## 8A Miscellaneous Electrical Systems

The information in this appendix of the reference ABWR DCD, including all Subsections and figures, is incorporated by reference with the following departures and supplements.

FIGURE 8A-1 SITE PLAN (GROUNDING)

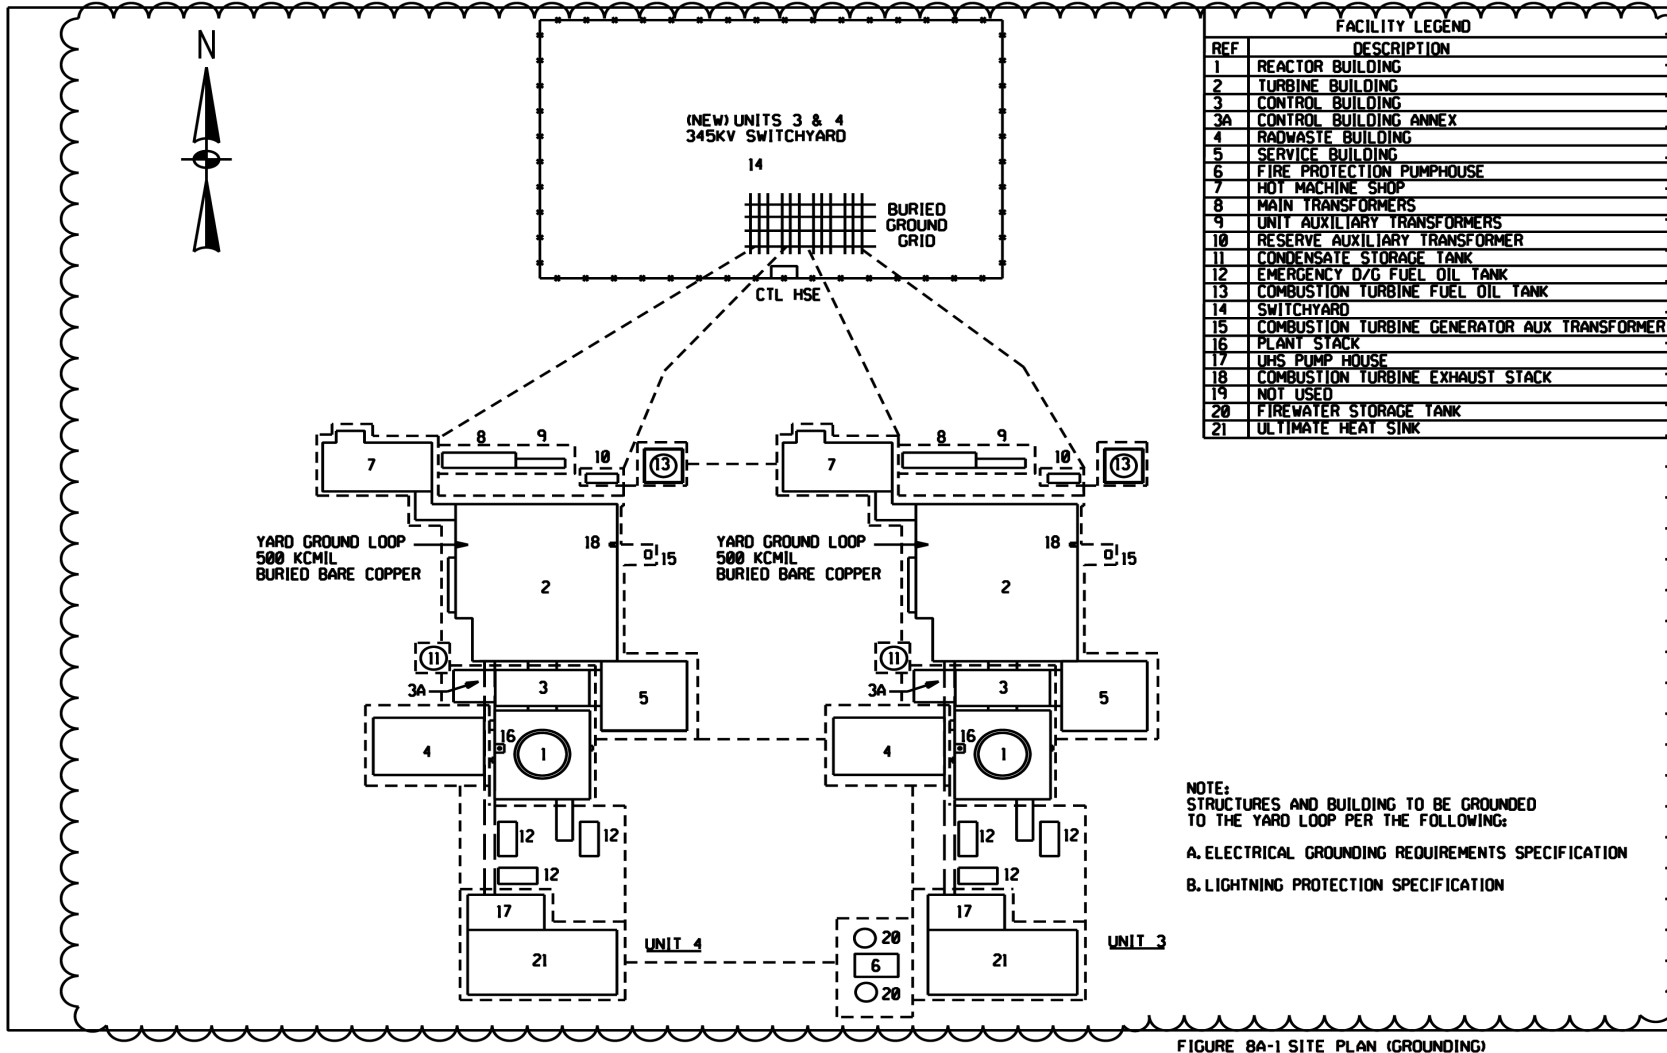
STP DEP 1.1-2 (Figure 8A-1)

STP DEP 1.1-2

- (3) A plant grounding grid shared between STP Units 3 & 4
